то	Zac Lovell	DATE	21/10/2025
FROM	Josh Farner	TIME	
PROJECT	New Tasmanian Youth Justice Facility	PROJECT Nº	24.0447
SUBJECT	Response to Council RAI	REF Nº	EA-C02

A Request for Additional Information (RFI) was received from Southern Midlands Council for the proposed Tasmanian Youth Justice Facility (DA2500106) on 30 September 2025.

The additional information concerning to the site Civil design has been provided in Civil Engineering Drawings and a revised Concept Services Report, both dated 21 October 2025. This Engineers Advice provides a summary of the RFI information provided in these documents, and provides further detail where required. It should be noted that the design drawings are for the purpose of concept design for development approval. Further engineering design will be carried out during the detailed design phase to produce the final design and documentation for construction.

SCALE 1:500H 1:100V@A1 DESIGNED DRAWN CHECKED DH PROJECT DRAWING REVISION 24.0447 C214 Α

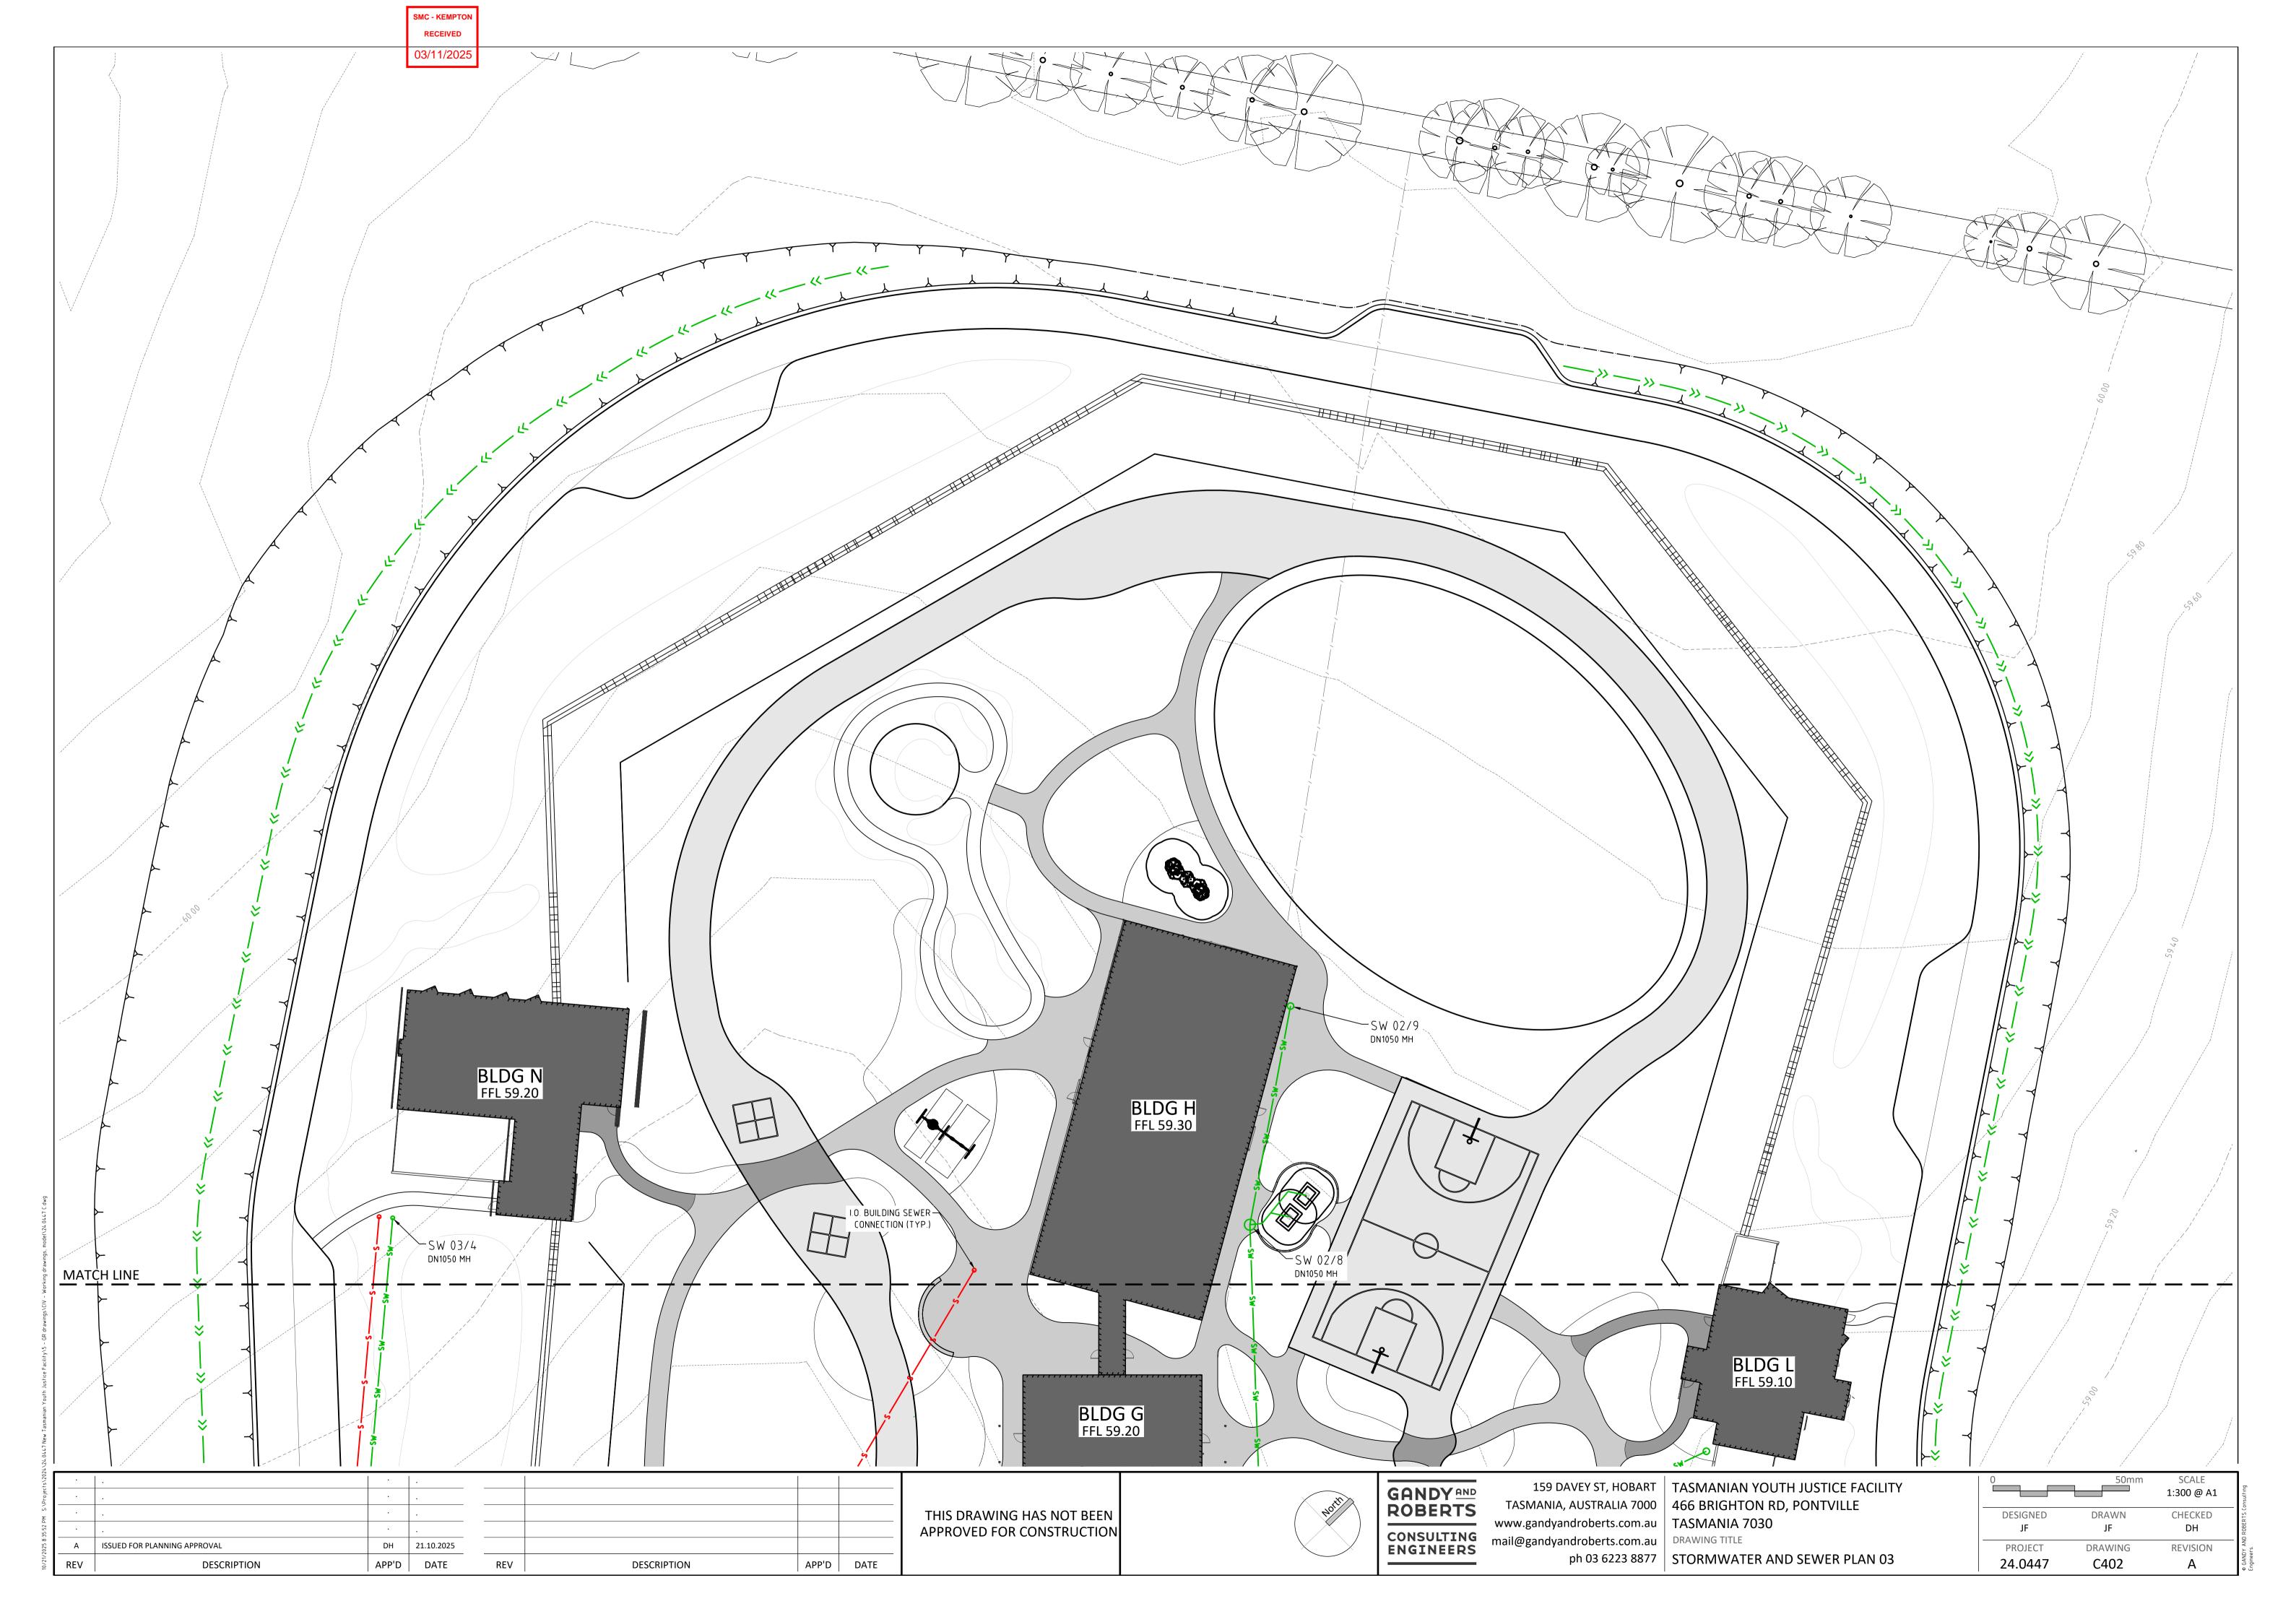
• Provide stormwater long sections for major internal stormwater alignments, sized to convey the 5% AEP storm event.

Concept stormwater design longitudinal sections are provided in drawings C410-412. Detailed hydraulic design of the system to cater for the 5% AEP rainfall runoff shall be undertaken for building approval, once the detailed landscape design is finalised. As noted in the concept services report, on site detention shall be provided to ensure that post development runoff (up to a 5% AEP rainfall event) does not exceed the 5% AEP pre-development runoff.

TYPICAL SECTION: ROAD 03
CAR PARK AND SWALE DETAIL
SECTION A

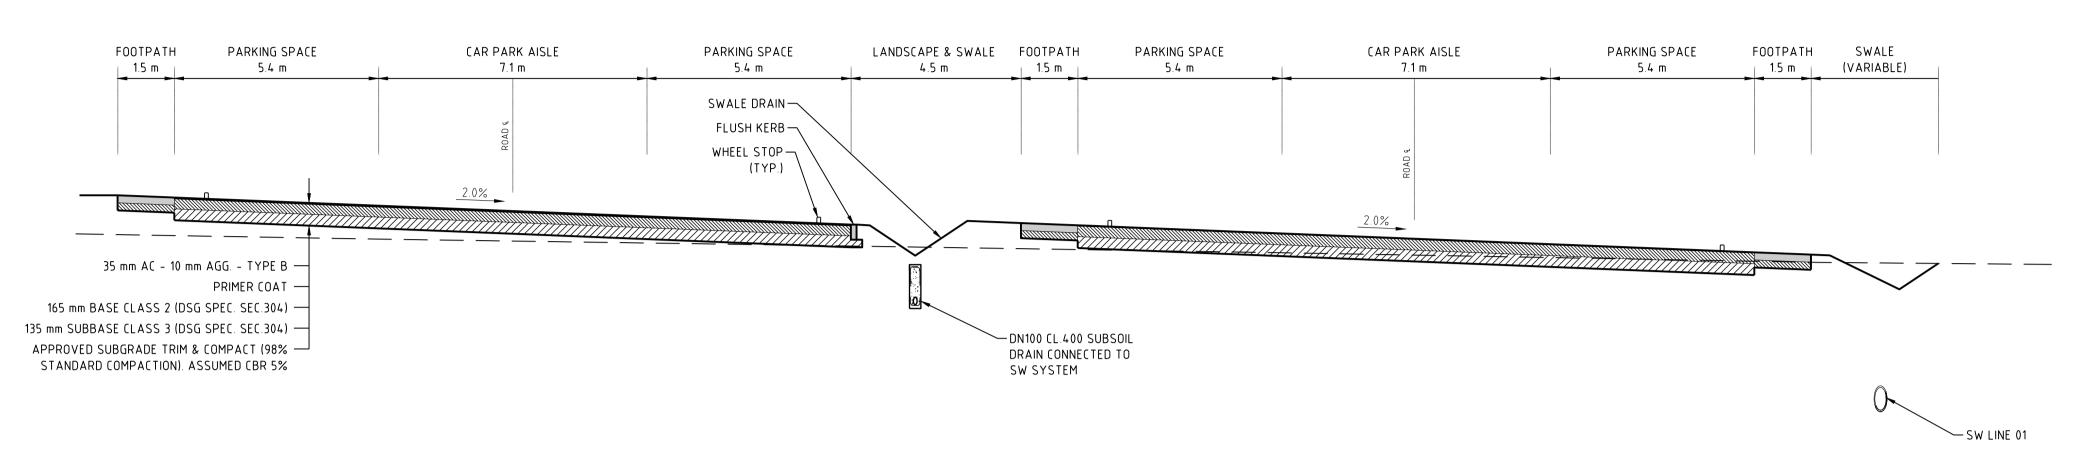
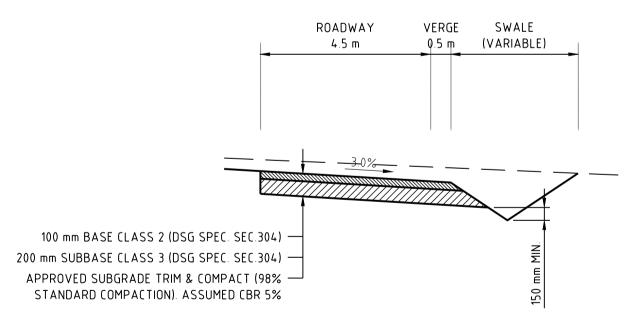
Provide details for general stormwater concepts for drainage of fire truck access road and building

Refer drawing C700 for typical roadway cross sections and drawings C400-402 for site stormwater plans.

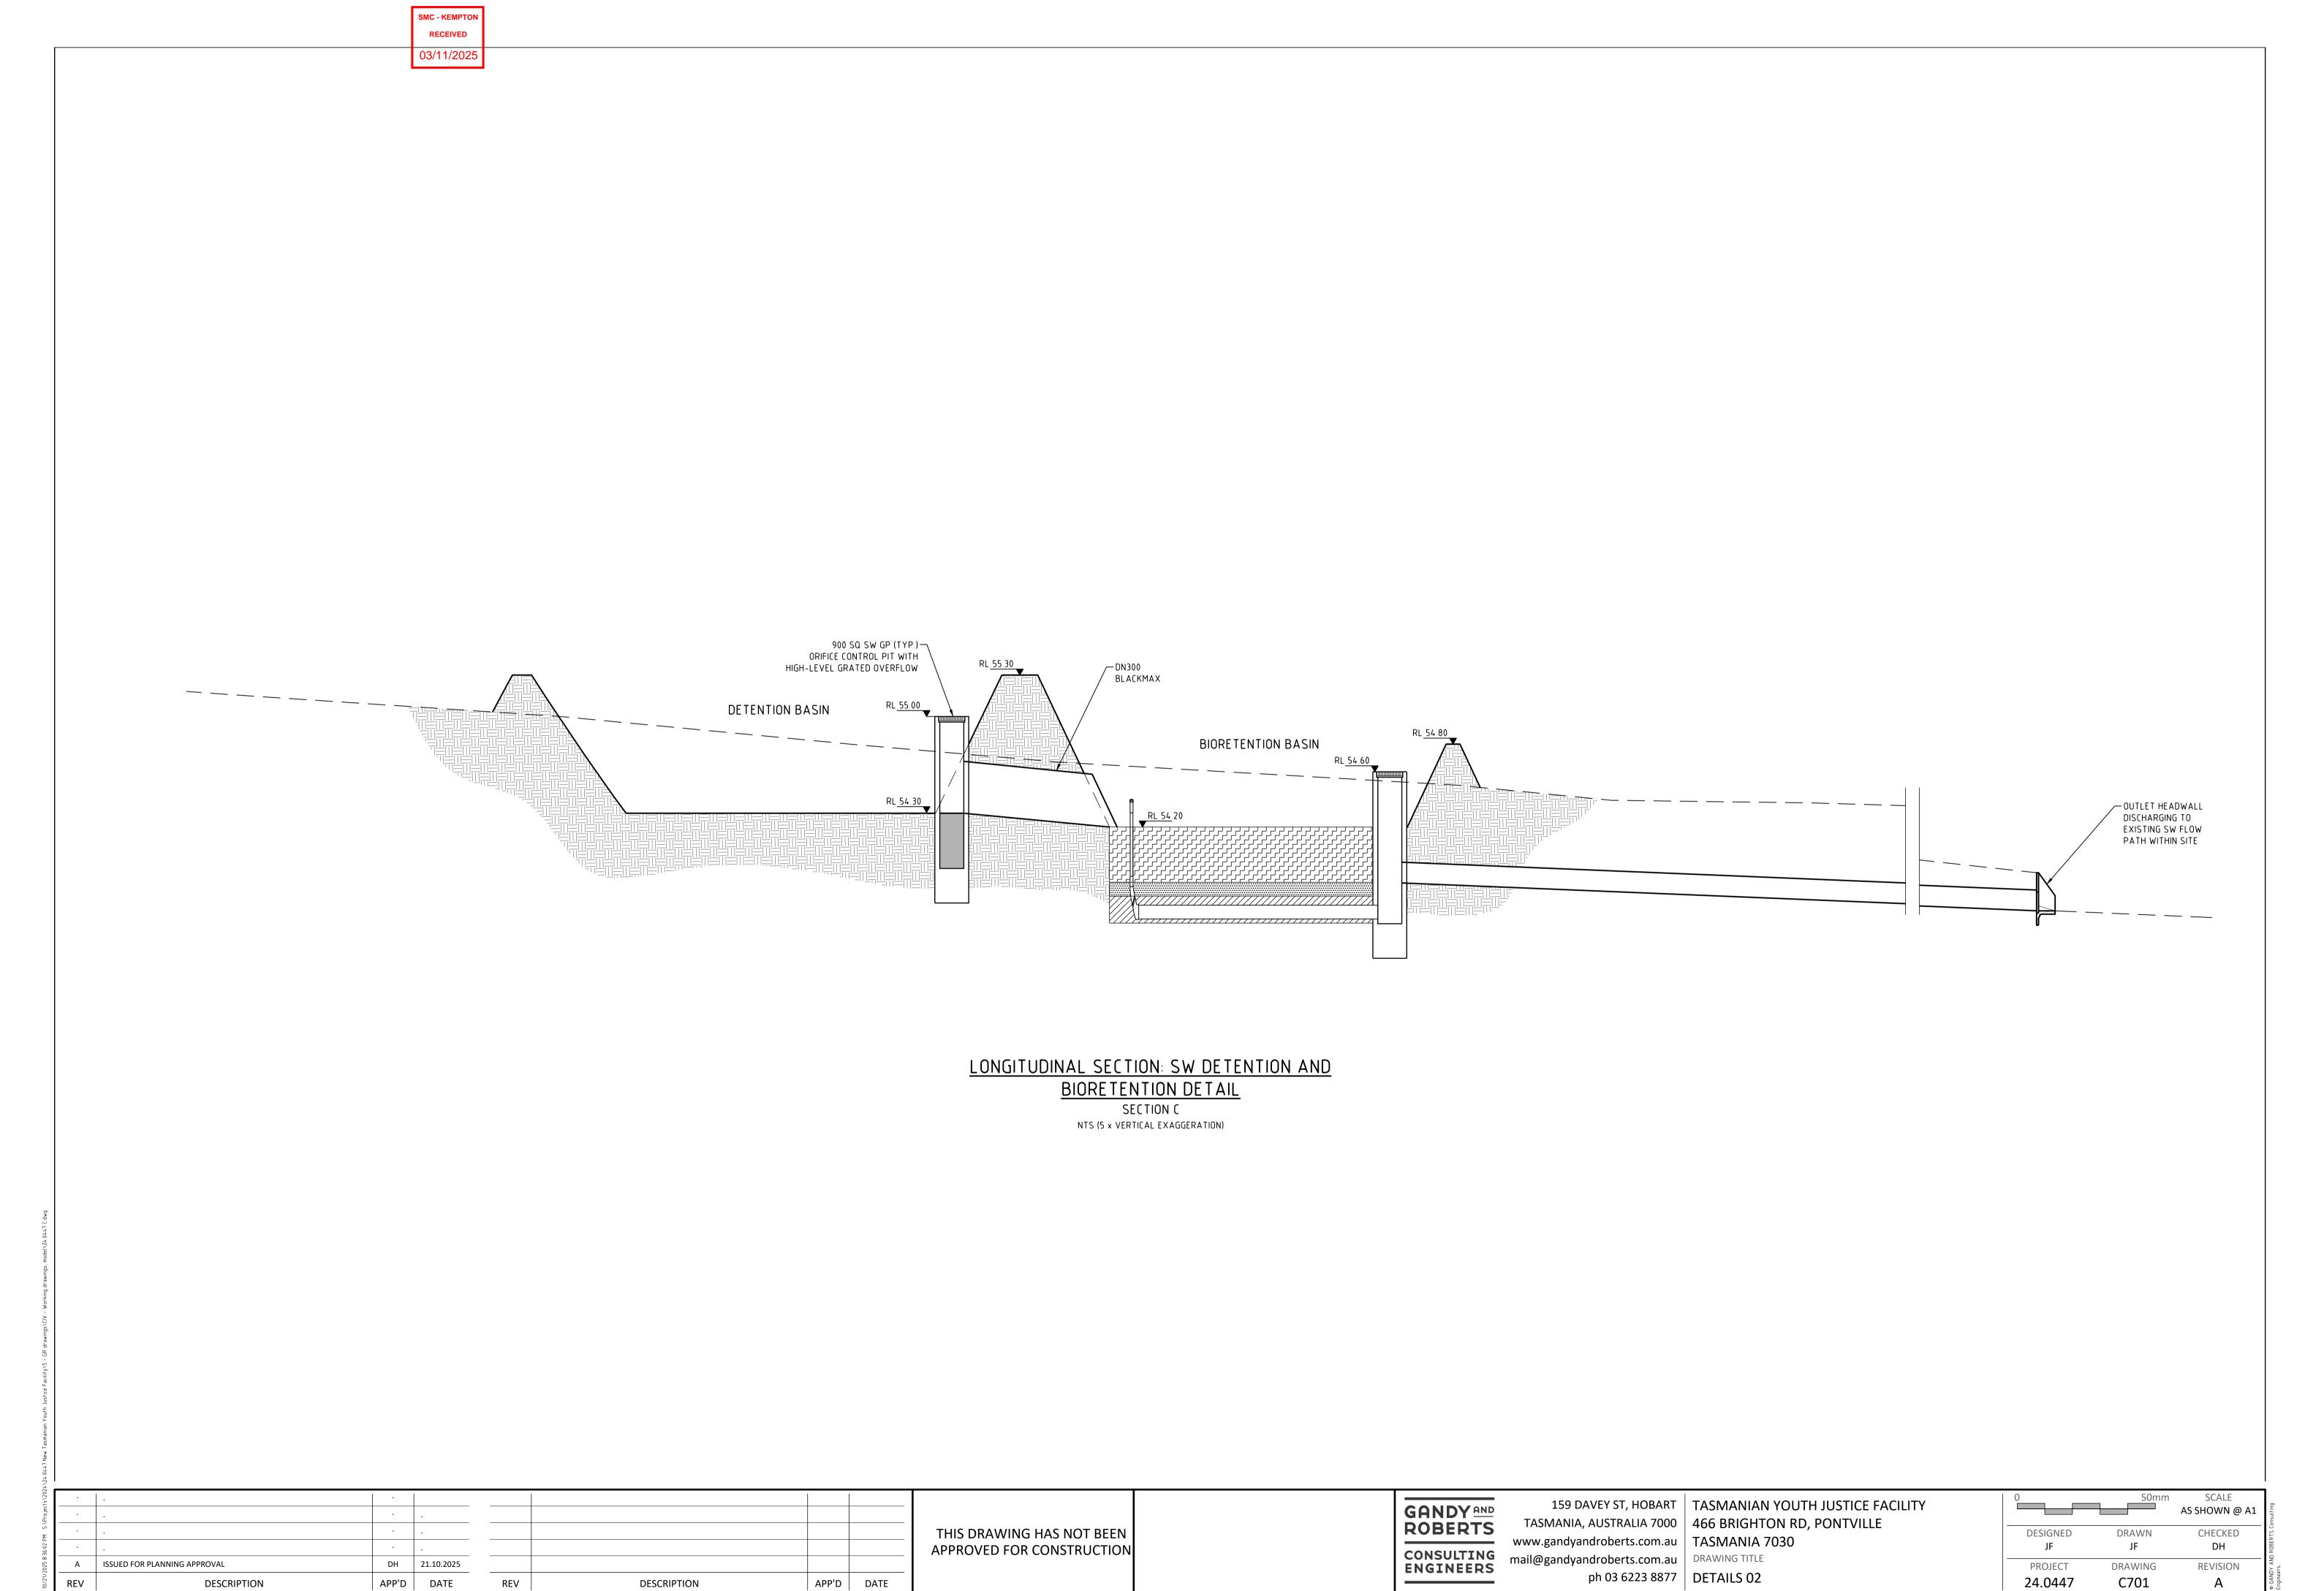
Refer Pitt and Sherry for design of this portion of the works (design by others).
- Provide cross sections of detention and bioretention basins with invert levels of stormwater infrastructure and bypass system for major events.

- Refer drawing C701 for a cross section of the concept design detention and bioretention basin arrangement and outlet pipe. Refer drawing C400 for plan detail and detention basin overflow channel schematic design.
